Design Adjustment Application

PROJECT	Project Name Brier Creek / Aviation Parkway South - Preliminary Subdivision		
	Case Number S-13-18		
	Transaction Number #549097		
OWNER	Name Tim Dockery (CIP Brier Creek LLC)		
	Address 111 E. Hargett Street		City Raleigh
	State NC	Zip Code 27601	Phone 336-678-4125
CONTACT	Name Richard Brown, PLA		Firm Kimley-Horn
	Address 421 Fayetteville St		City Raleigh
	State NC	Zip Code 27601	Phone 919-653-2976
REQUEST	I am seeking a Design Adjustment from the requirements set forth in the following:		
	<input checked="" type="checkbox"/> UDO Art. 8.3 Blocks, Lots, Access	- See page 2 for findings	
	<input checked="" type="checkbox"/> UDO Art. 8.4 New Streets	- See page 3 for findings	
	<input checked="" type="checkbox"/> UDO Art. 8.5 Existing Streets	- See page 4 for findings	
	<input checked="" type="checkbox"/> Raleigh Street Design Manual	- See page 5 for findings	
	Provide details about the request; (please attach a memorandum if additional space is needed): (SEE ATTACHED MEMORANDUM FOR MULTIPLE DESIGN ADJUSTMENT REQUESTS)

**Subject: Design Adjustment Requests
Brier Creek / Aviation Parkway Subdivision (S-13-18; Transaction # 549097)**

2	TYPICAL PUBLIC UTILITY SECTION - PROPOSED CONFLUENCE DRIVE - AVENUE 2-LANE DIVIDED	
C20	SCALE: 1"=10'-0"	SECTION

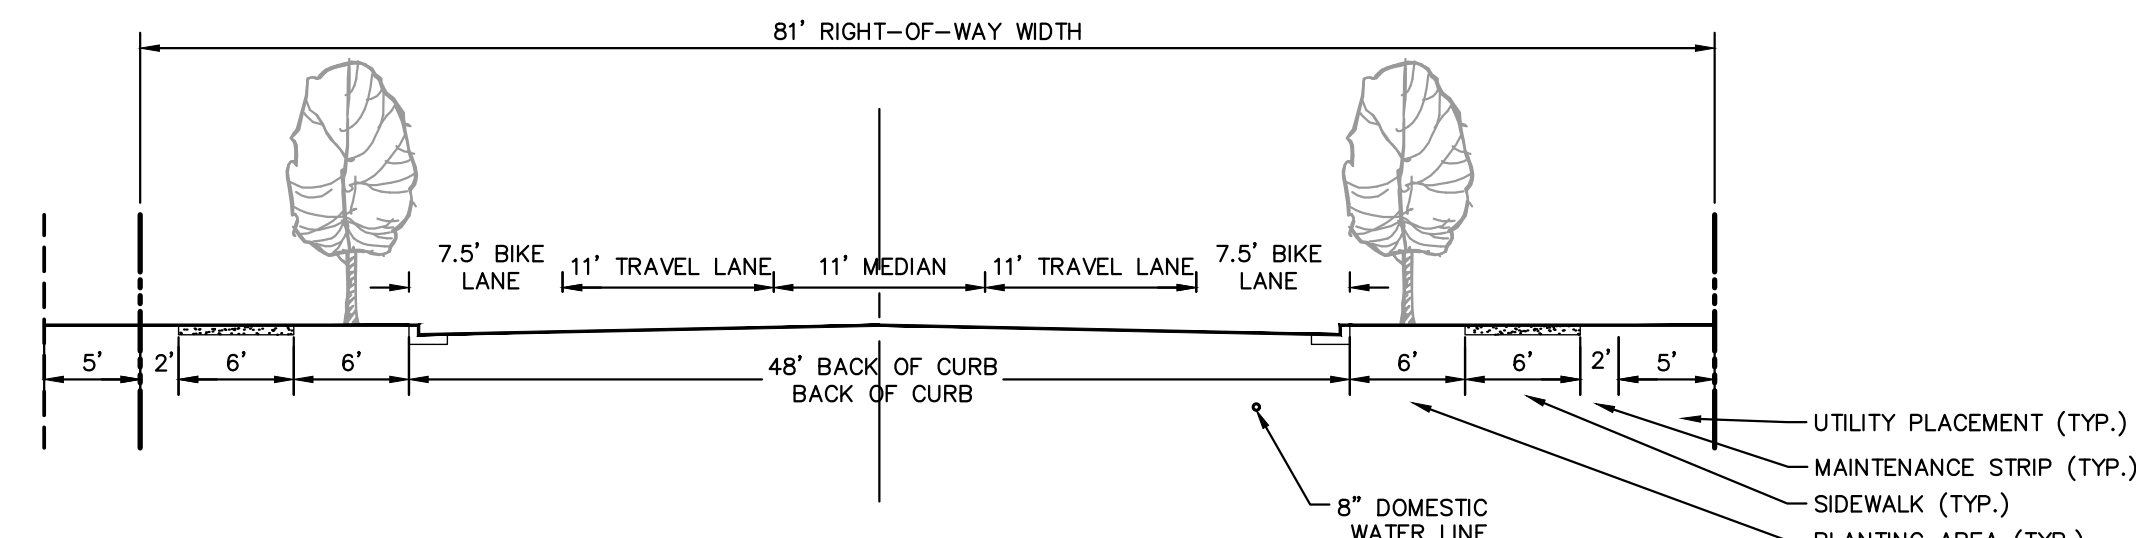
Request #2 – Right of Way/Streetscape Dimensions for new public street (Confluence Way)

- Article 8.4.5 specifies a dimensional criteria for Avenue 2-lane divided street. The design adjustment request applies to Confluence Drive (new street) and specifically to the proposed alternate dimensional criteria (excerpt below).

- Confluence Way is proposed as a new street with center turn lane. The proposed right of way width for this street (81') exceeds the 79' requirement. This is proposed in order to avoid a non-conforming lot between the r/w and the adjoining residential lots to the east and to allow grading tie-outs within the proposed r/w.

- The 48' b-b road width as well as all other dimensional criteria is provided.
- The applicant believes that the intent of Article 8.4 is being met.
- The applicant believes that the design adjustment conforms to the Comprehensive plan and relevant adopted city plans.

SUBDIVISION PLAN

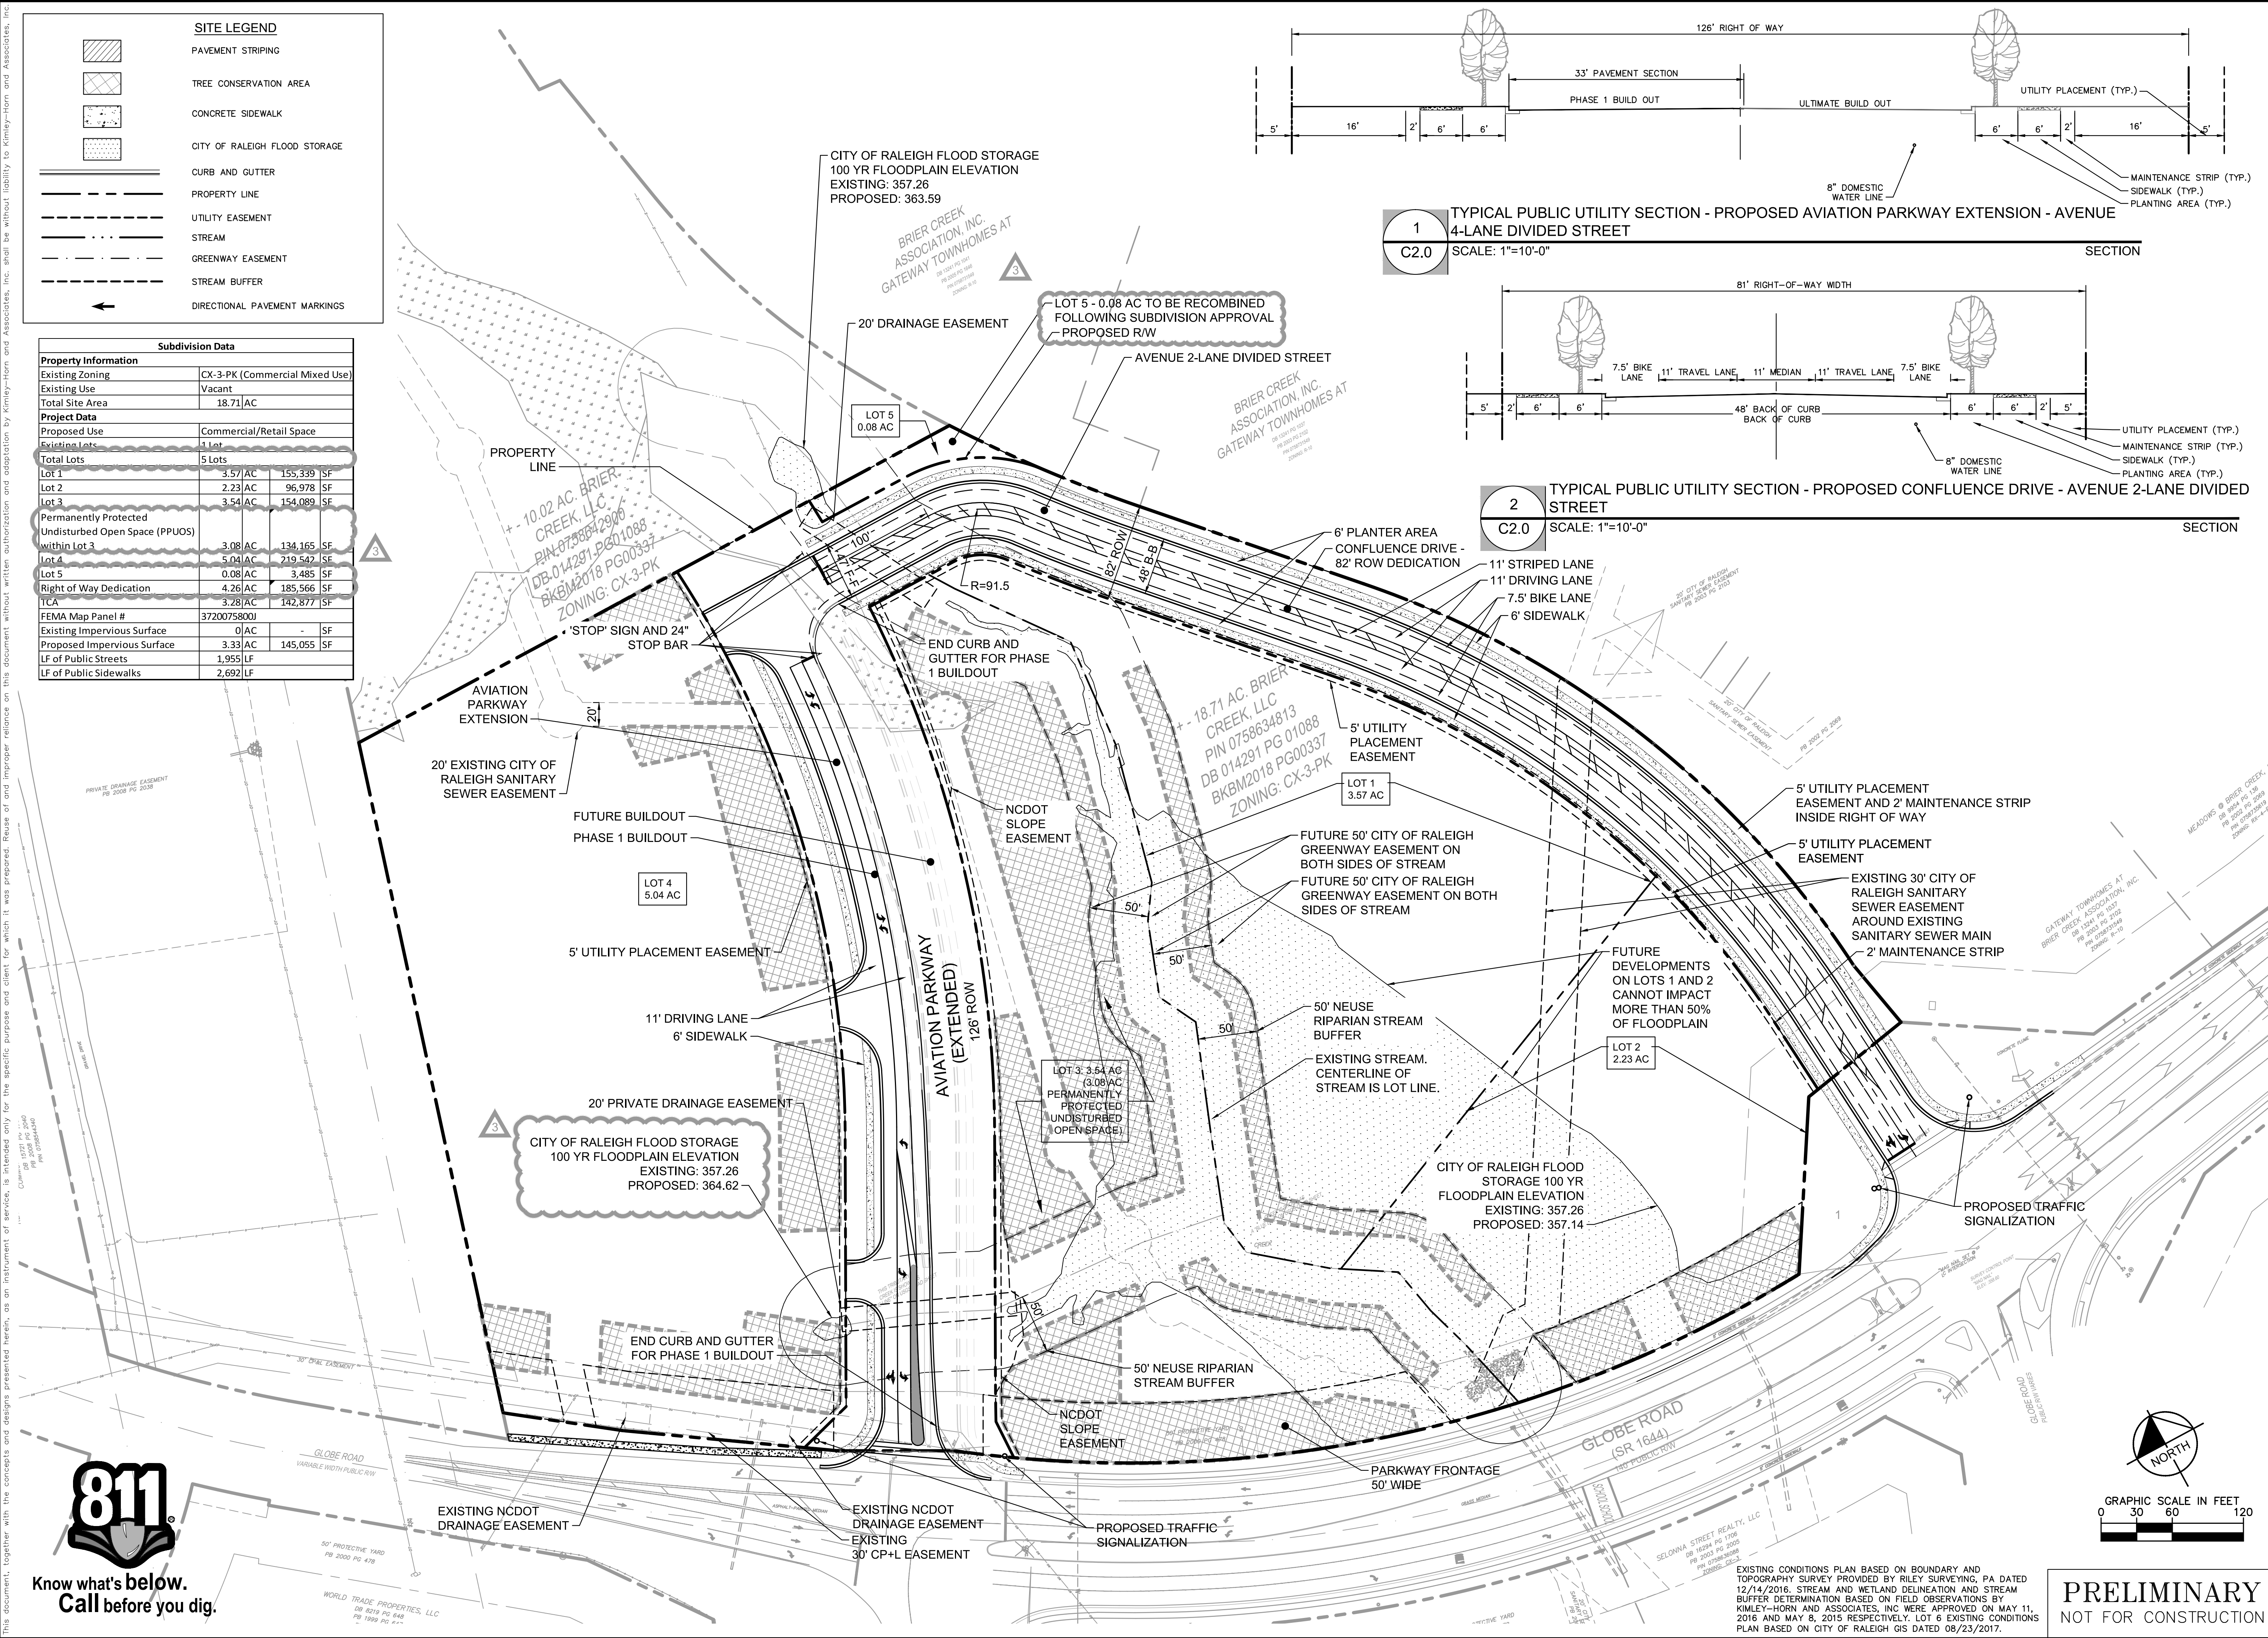
Request #1 – Utility Placement Easement (Globe Rd and Proposed New Street)

- Article 8.5 requires a 5' utility placement easement along the public street frontages. The design adjustment request applies to Confluence Way (new street) and Globe Rd. frontage.

- Along the Globe Rd. frontage, west of the Aviation Pkwy extension, there is an existing overhead power easement in which future utilities can be placed. Additionally, along the frontage east of Aviation Pkwy., there is 8.5' between the back of sidewalk and the right of way line where future utilities may be placed.

- Confluence Way is proposed as a new street. The right of way line for this street is also the existing eastern property boundary; therefore, there is no land area within the control of this applicant where the easement can be placed. Thus, the utility (if required) is proposed to be within the new right of way.

Request #3 – Minimum Centerline Radius for Avenue 2-lane divided public street

The Raleigh Streets Manual specifies a minimum center line radius of 375' for an Avenue 2-lane divided street. The design adjustment request applies to Confluence Drive (new street) and specifically to the proposed alternate centerline radius of 91.5'.

- Confluence Way is a short street connection from Globe Rd. to Aviation Pkwy extension and is required to cross the existing stream within a relatively short distance. There are also several environmental stream and buffer impact controls (by the ACOE) dictating the alignment of the stream crossing and intersection with Aviation Pkwy extension.

- Based on multiple discussions with city transportation, it is understood that the property is physically constrained and unable to meet the specified 375' minimum radius.

- Furthermore, the street is designated as part of a future “square loop” interchange with a stop condition at both Aviation and Globe, and therefore may not need to function horizontally as a true 2-lane divided street. Volumes and speed should be fairly low on this segment of street.
